Product Change Notification: P-21-021457

PCN Date: 16-SEP-21

OMR Reed relay

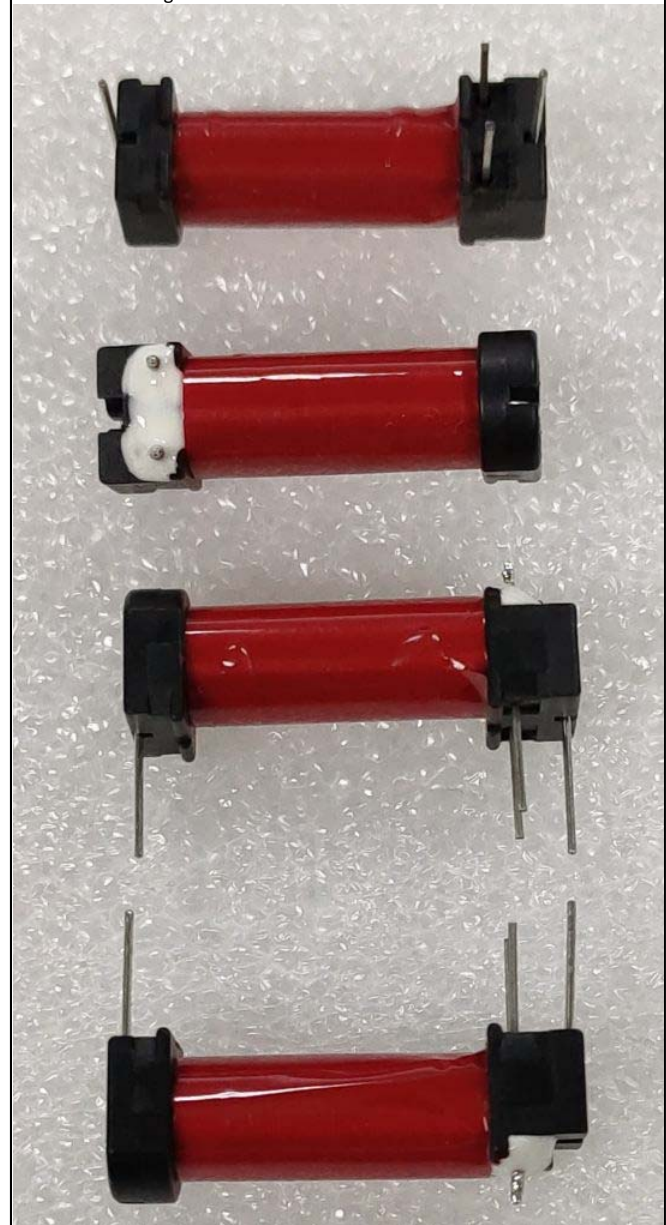
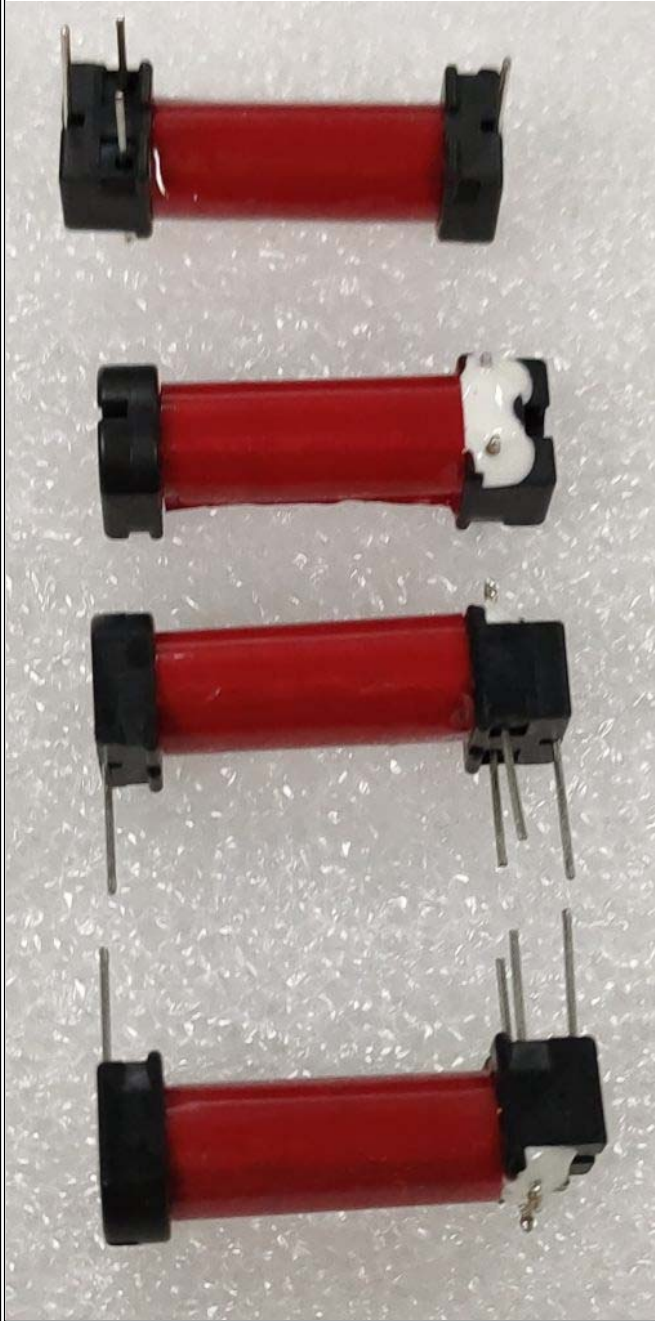
Change the material of epoxy which is used to stick on coil tape. The change will affect appearance of tape and no affective to fit and fuction.

Reason for Changes:	
Product improvement.Change the material of epoxy which stick the tape of the coil, in order to compliance with China Volatile Organic Compound (VOC) regulation.	
Estimated Dates:	
Last Order Date (Obsolete Parts Only):	First Date To Ship (Changed Parts Only):
	15-OCT-2021
Last Ship Date (Obsolete Parts Only):	Last Date for Mixed Shipments: (Changed Parts Only):
	31-DEC-2021
